**DRAFT**  
**EXPLANATION OF SIGNIFICANT DIFFERENCES**  
**CONTINENTAL STEEL SUPERFUND SITE**  
**FINAL RECORD OF DECISION, SEPTEMBER 1998**  
**AS AMENDED SEPTEMBER 2003**

**Indiana Department of Environmental Management**  
**August 2005**

*This fact sheet provides background and information about proposed changes to the Continental Steel Remedial Action including elimination of the Corrective Action Management Unit (CAMU), which was to be an on-site landfill.*

**Figure 8 Upper Aquifer Manganese Concentrations, From Technical Memorandum entitled Continental Steel Superfund Site Contract 5 – Groundwater, Groundwater Flow and Quality Conditions, prepared for EPA by CH2M HILL on February 7, 2003.**

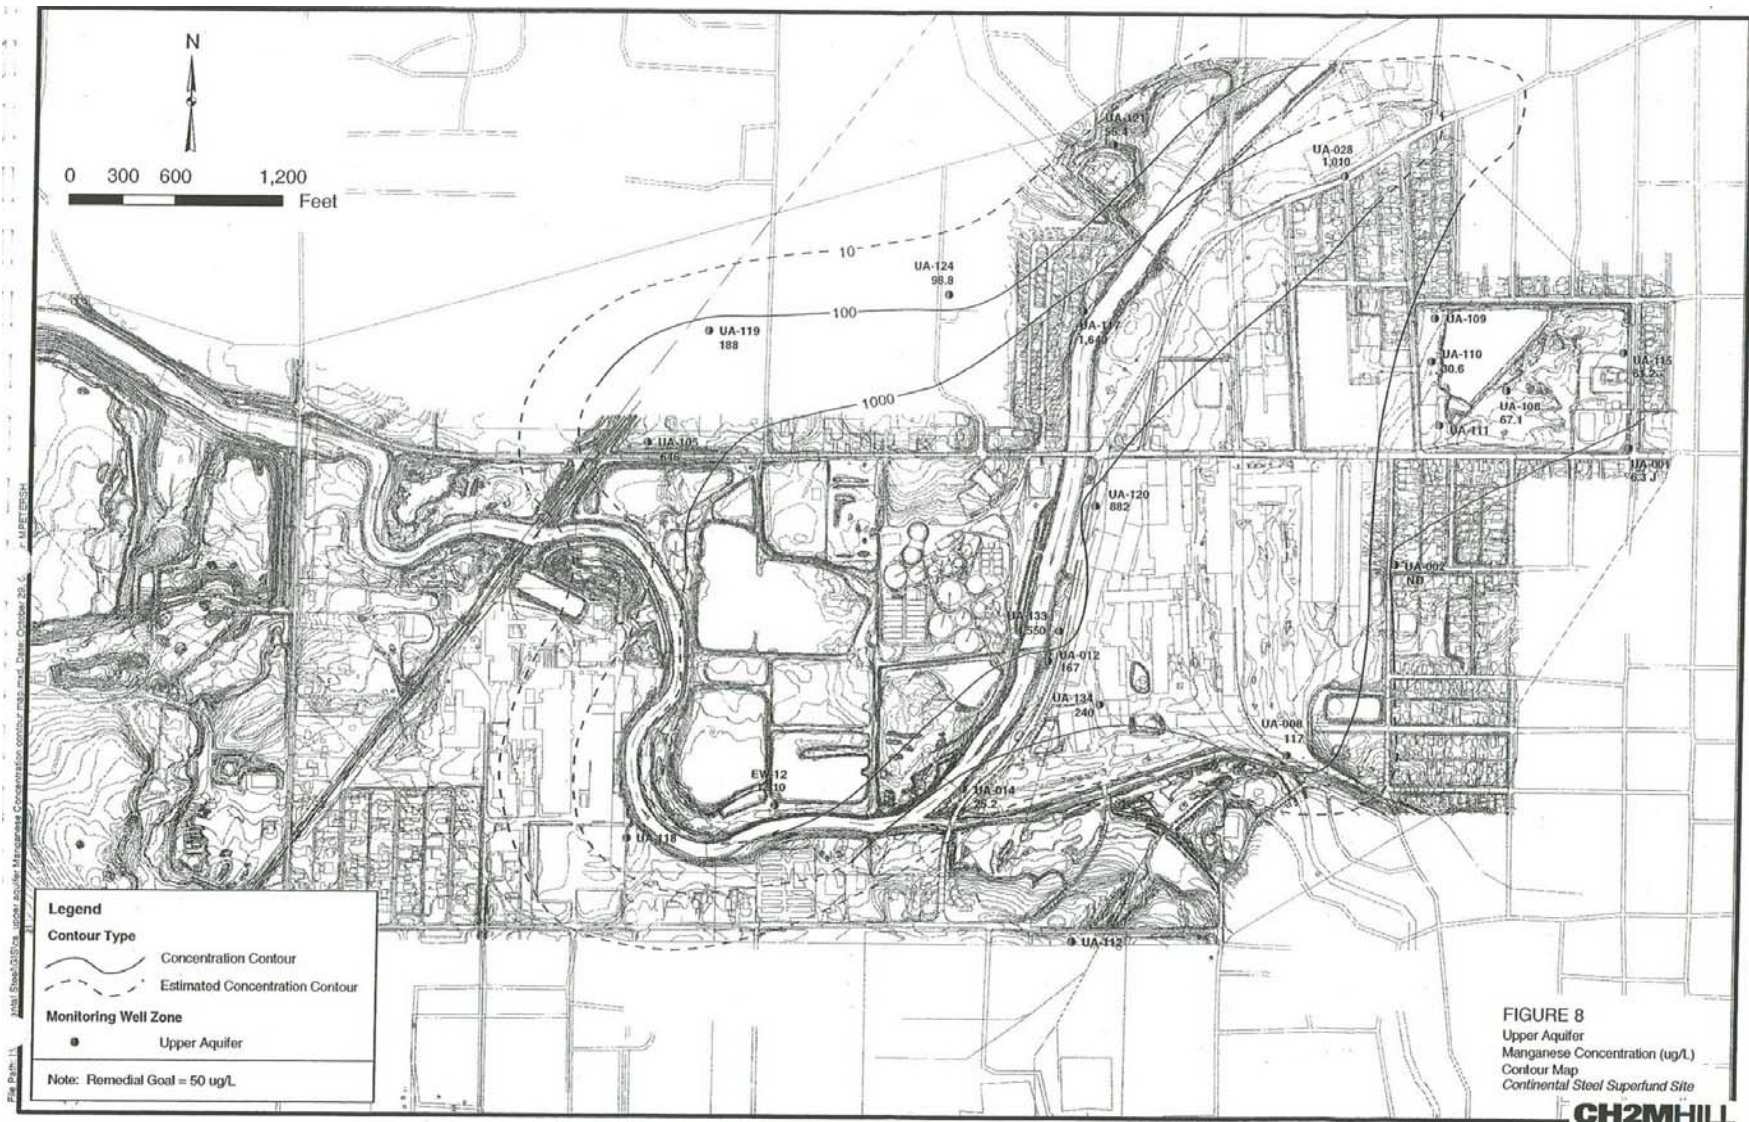
Groundwater data collected during the Remedial Investigation (RI) and the remedial design investigation indicate that this waste does not leach contaminants above Maximum Contaminant Levels (MCLs) into the groundwater. This is probably attributable to the fact that the sludge in the polishing lagoons and drying beds had been processed (mixed with lime) through the on site wastewater treatment plant when the facility was operating. IDEM's interim closure of the primary acid storage lagoons, performed in 1989, addressed the stored acid and untreated sludge. The primary acid storage lagoons had an extremely low pH, and the sludge at the base of these lagoons was untreated. The mixture of the sludge with lime likely reduced the leachability of the metal components and thus the mobility of these contaminants. As a result of the interim closure, the pH of the primary acid lagoon contents was raised and those lagoon beds now contain only treated sludge.

*(See Figures 4-8. These figures were originally published in the Technical Memorandum entitled Continental Steel Superfund Site Contract 5 – Groundwater, Groundwater Flow and Quality Conditions, prepared for **EPA** by **CH2M HILL** on February 7, 2003. The entire memo has been placed in the Administrative Record and is available for viewing at the Public Information Repositories [see Section IX of this ESD for locations]. Under current conditions, prior to **RCRA** closure of the lagoons, the only contaminant detected above **MCLs** in the Lagoon Area upper groundwater during the Remedial Design was Manganese. The **MCL** for Manganese is a secondary standard that may effect the taste or smell of drinking water).*

Surface impoundment closure that meets the requirements of **RCRA** will be performed as planned, however the lagoon contents will not be solidified to provide the base for a **CAMU**. The lagoons will not be consolidated, so the profile of the land will be more amenable to beneficial reuse. A cover will be placed over the entire area, similar to that applied at the Main Plant, Markland Quarry and the Slag Area.
